## 02 Landscape Redesign: Proposal Overview

PEARS BUILDING

FOOTPATH PRE APPLICATION DESIGN MEETING  
MINUTES

Project	Pears Building
Date	Thursday - 28.06.2017
Time	14:30 – 16:00hrs
Meeting Ref.	Footpath – Pre App Design Meeting
Location	5 Pancras Square

**Fig 2.4** (1) Section of low wall removed and replaced with a kerb to minimise disturbance to existing trees.

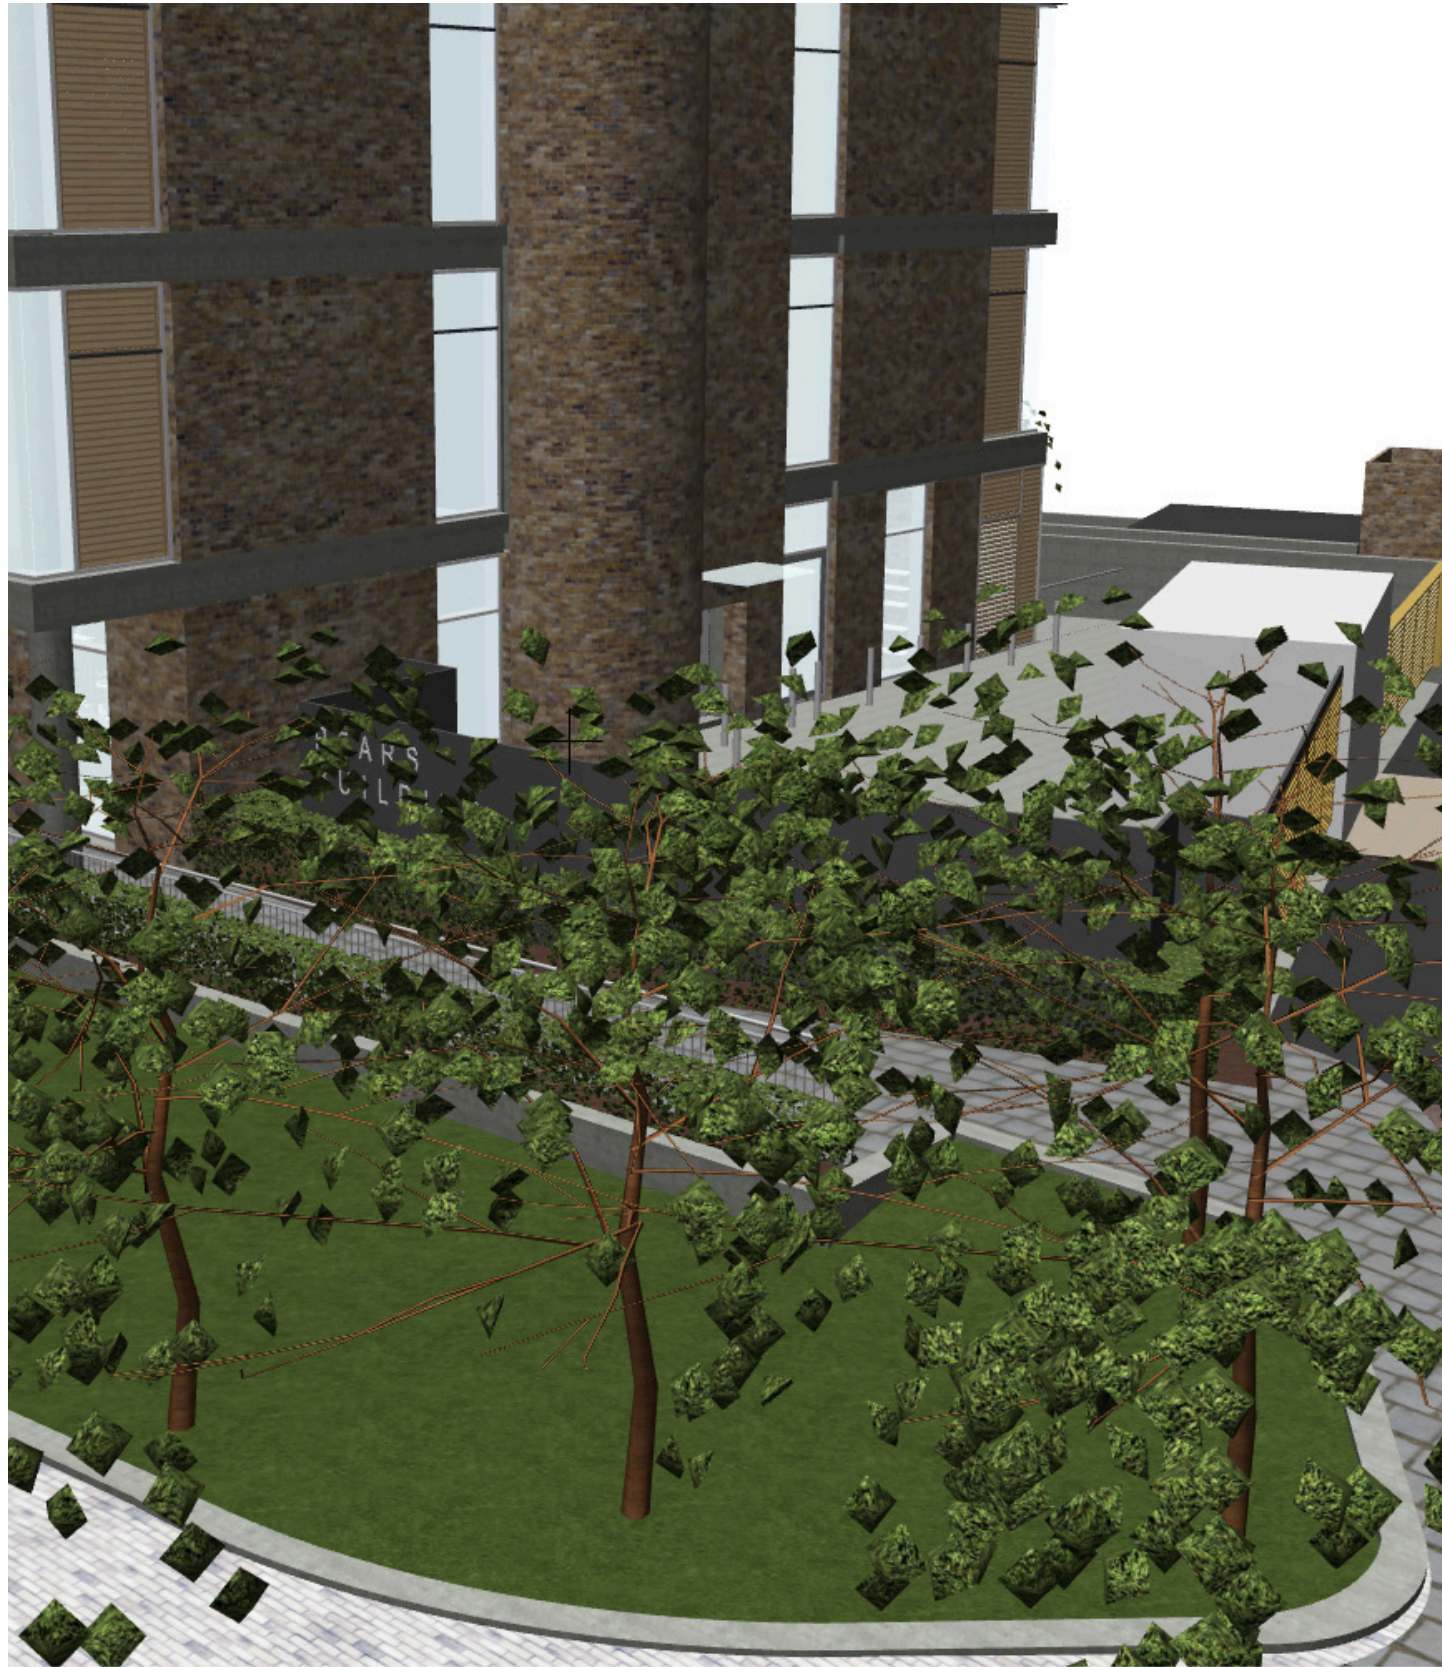
**Fig 2.5** (2) Stair pushed back / side walls removed

**Fig 2.6** (3) Shape of main entrance stair revised to accommodate the reduced width of the landscape.

**Fig 2.7** (5.1) Staircase relocated to align with the entrance of the Charity Offices.

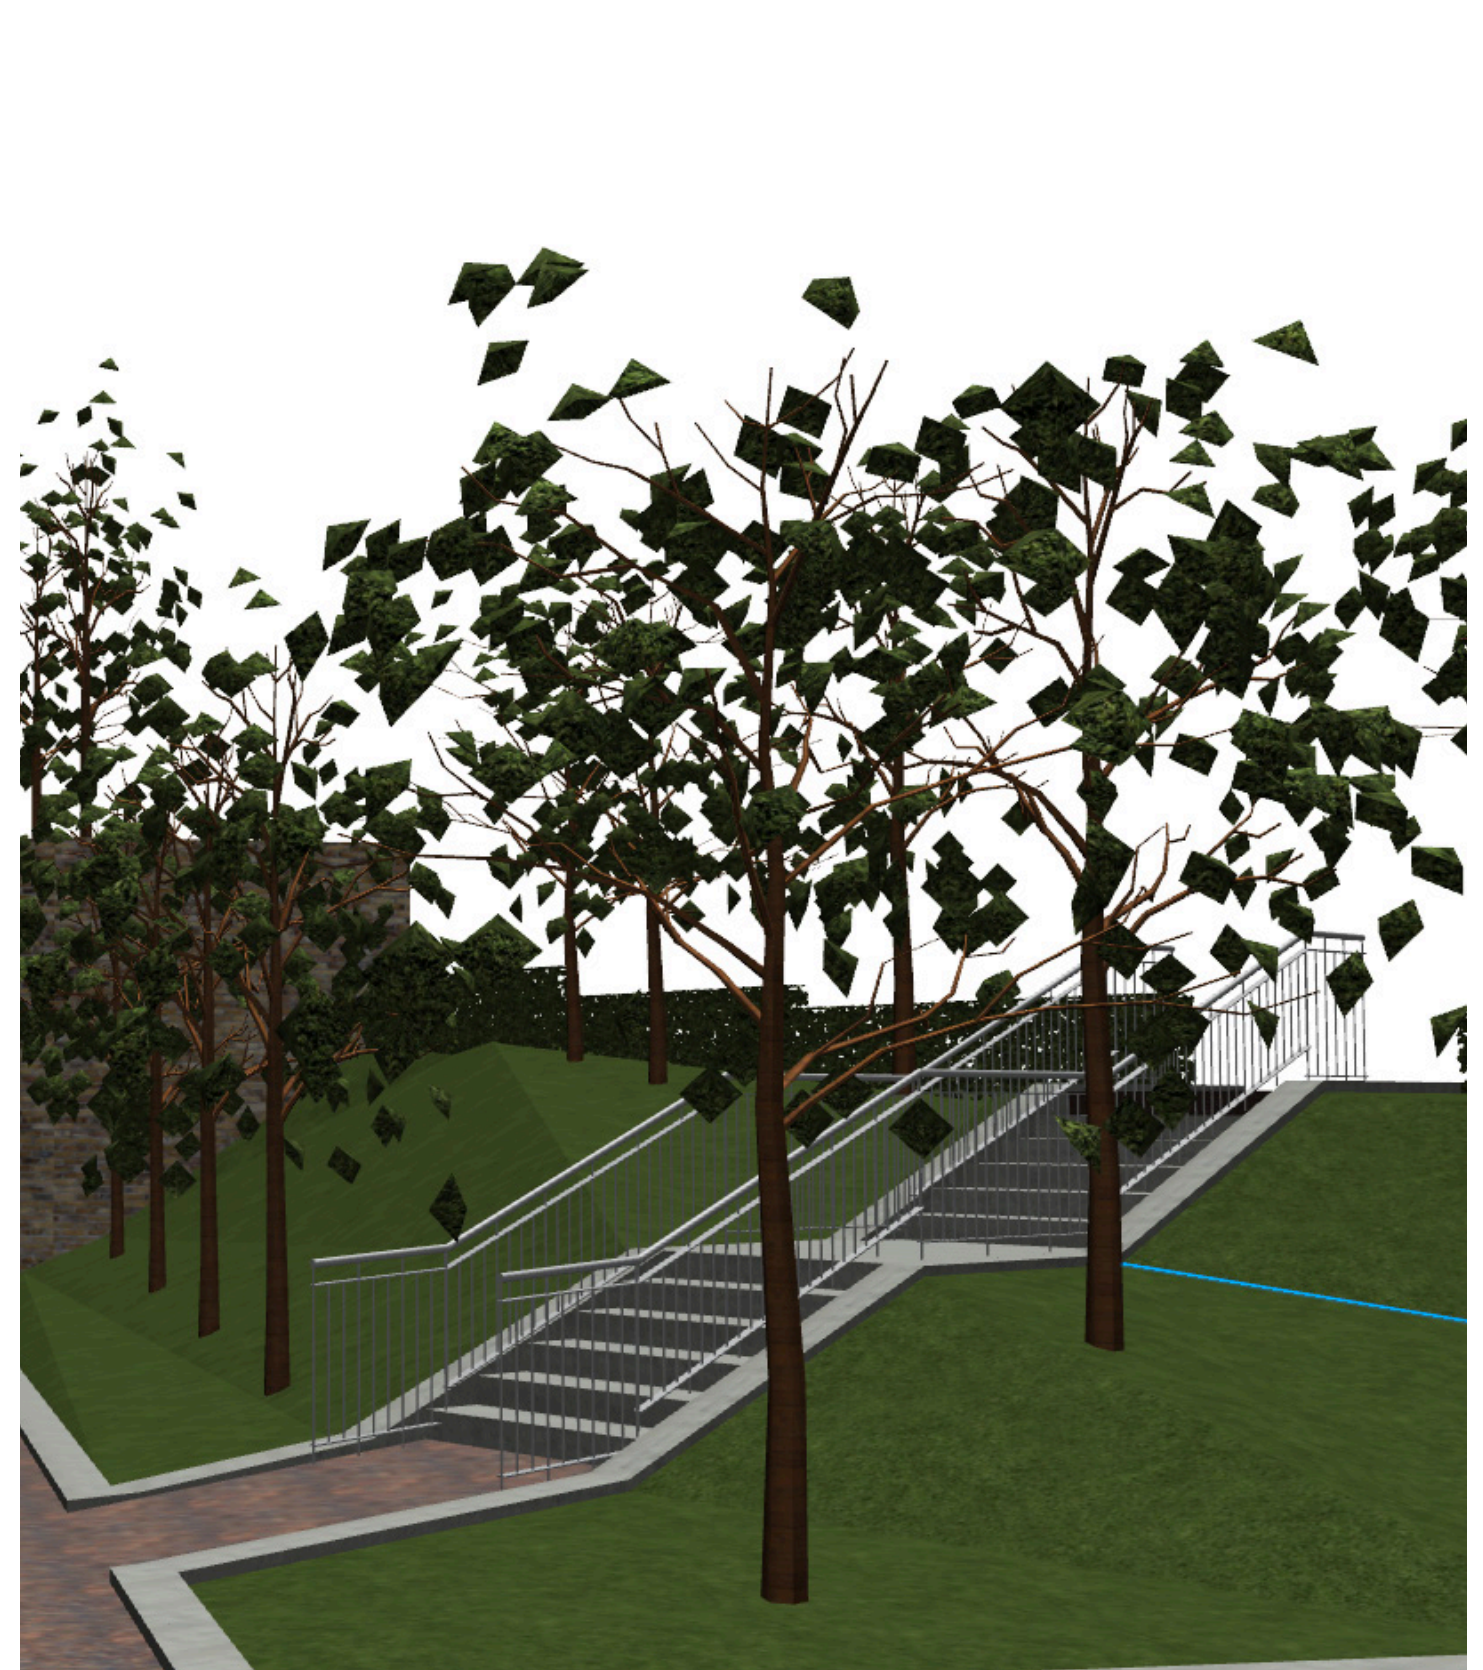
Fig 2.8 (4) North-West corner revised

**Fig 2.9** (5) Staircase / Landscape and courtyard reconfigured / 6) Staircase moved (7) One additional disabled car park space added
